DRAWING TITLE
BLDG 8 DIXIE ELEVATIONS

PROJECT TITLE
SLVHCS REPLACEMENT MEDICAL
CENTER PROJECTLOCATION
NEW ORLEANS, LOUISIANADATE
July 16, 2012CHECKED
CDDRAWN
DDPROJECT NUMBER
629-HS2-401
DOCUMENT SET PACKAGE
WP_9BDRAWING NUMBER
8AS250OFFICE OF
CONSTRUCTION
AND FACILITIES
MANAGEMENT

DIXIE SOUTH ELEVATION
1/8" = 1'-0"DIXIE WEST ELEVATION
1/8" = 1'-0"

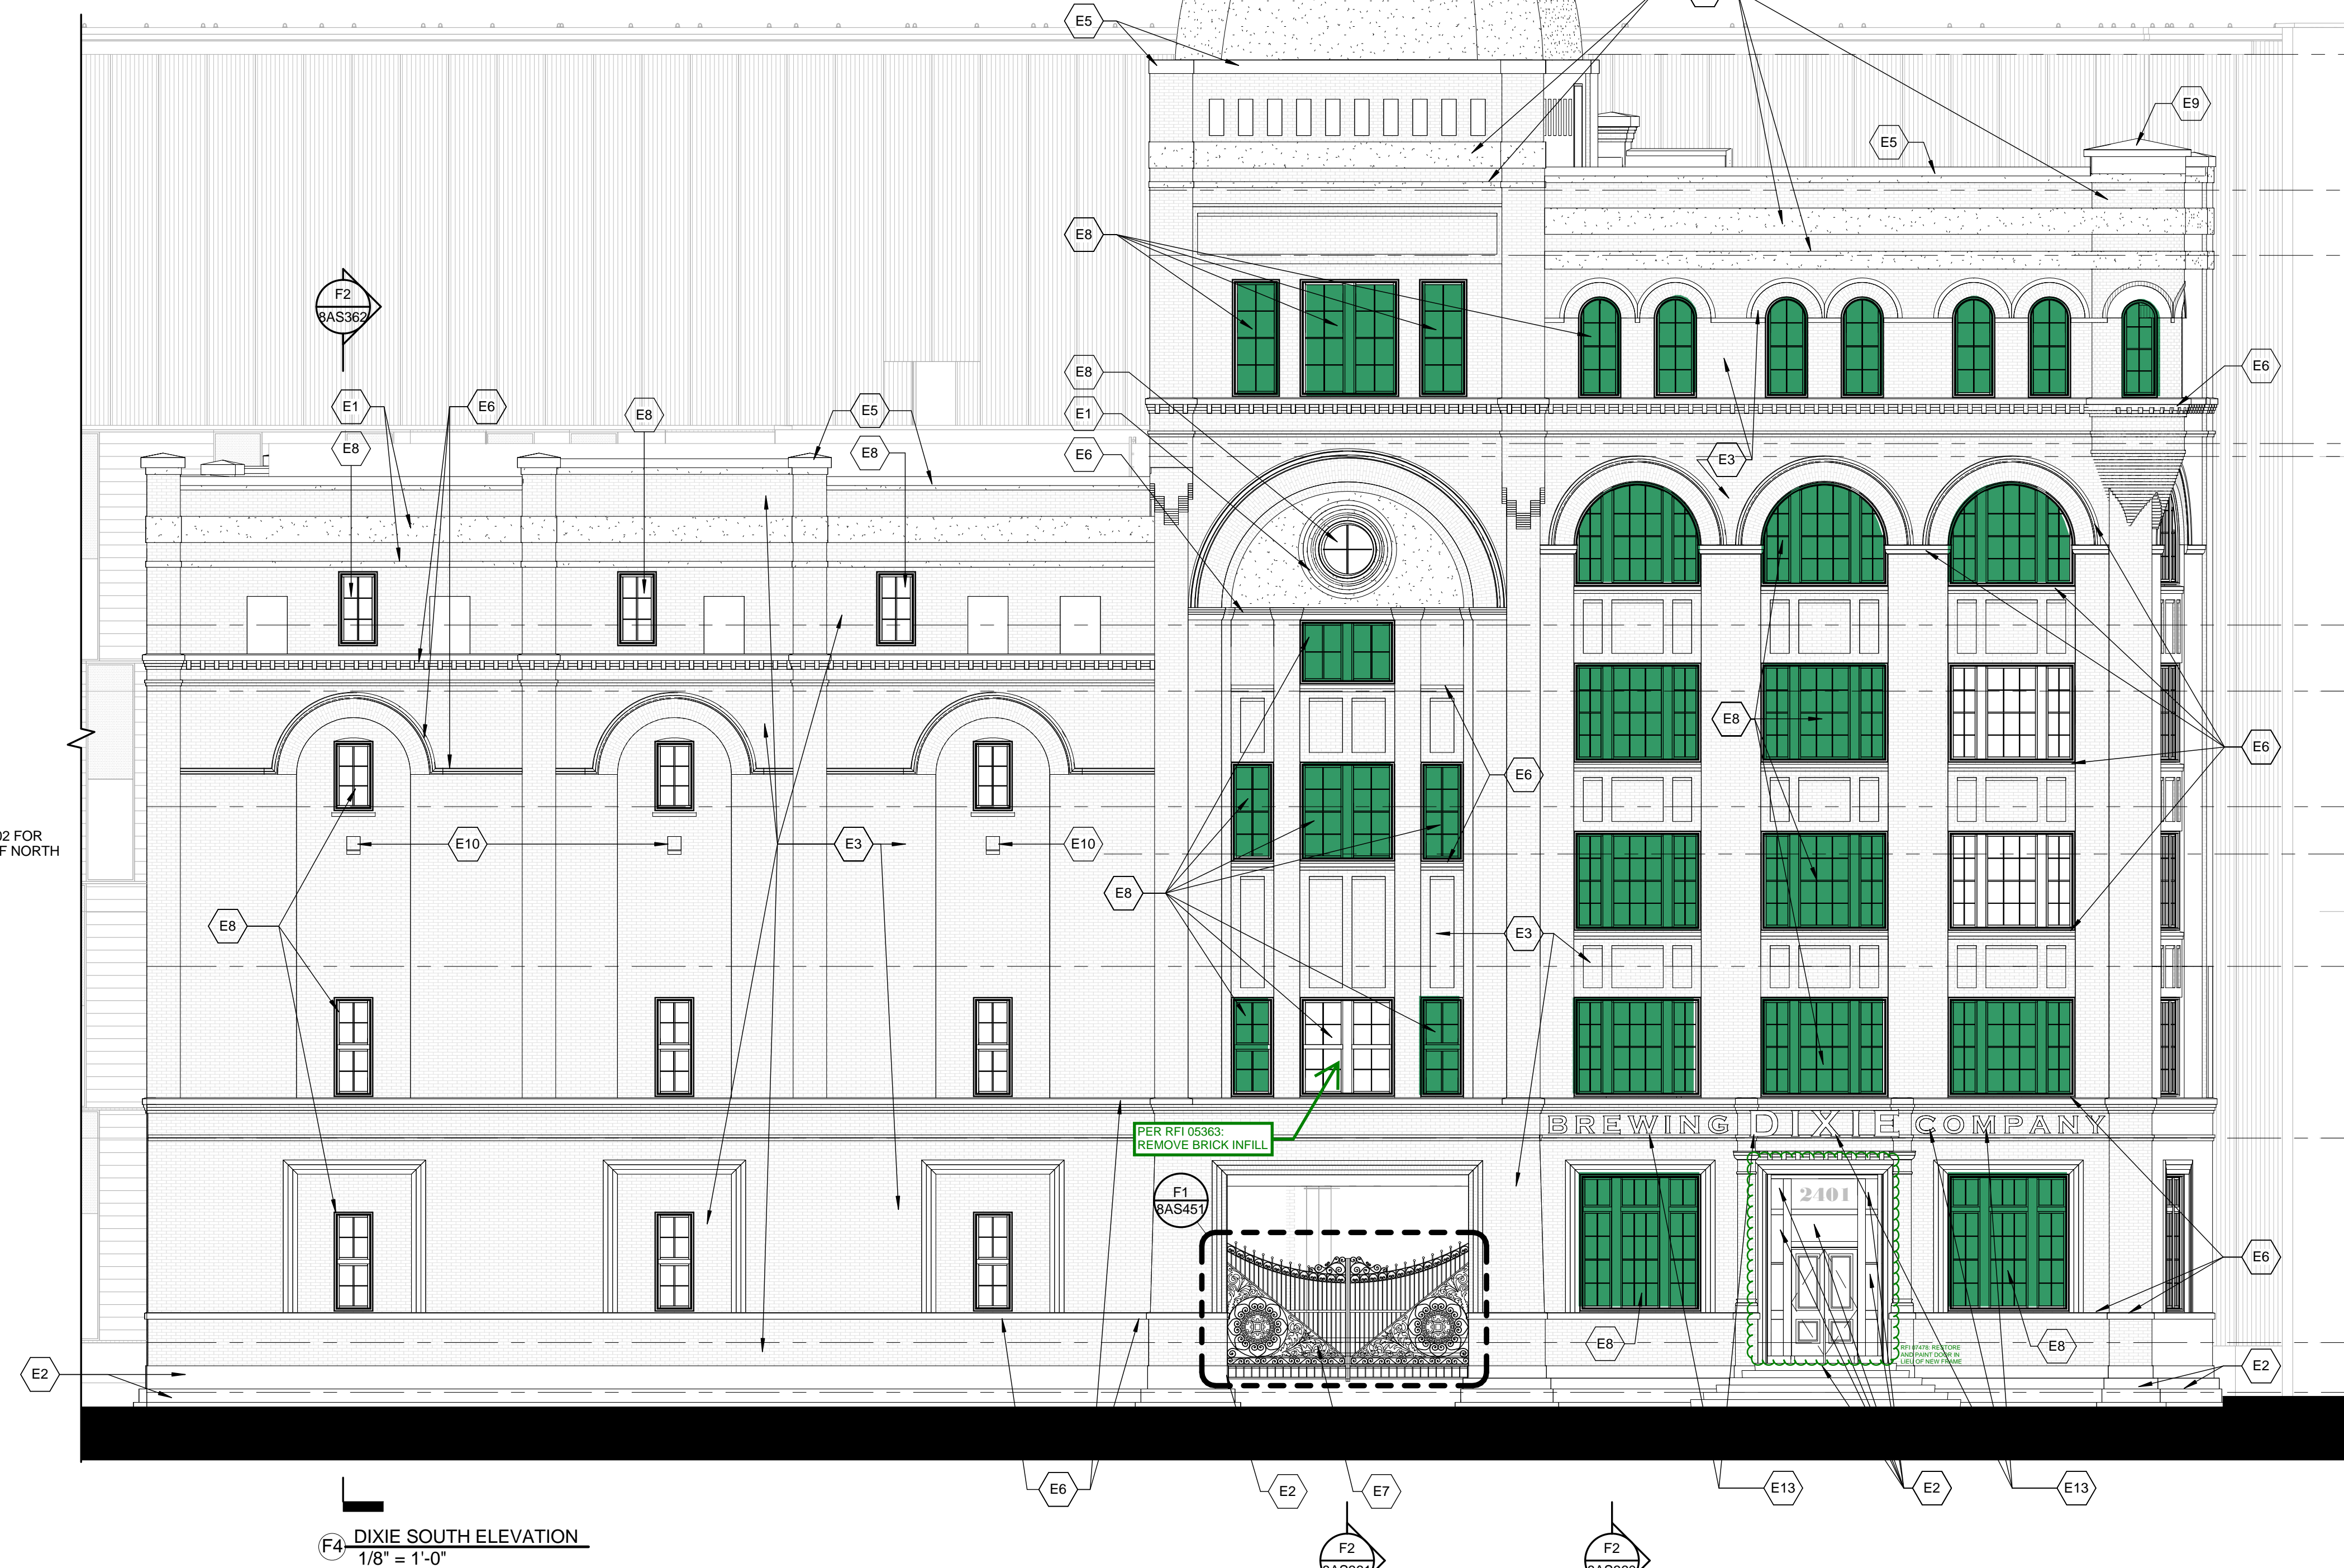
INFILL WINDOW JAMBS AS DESCRIBED IN RFI 5706
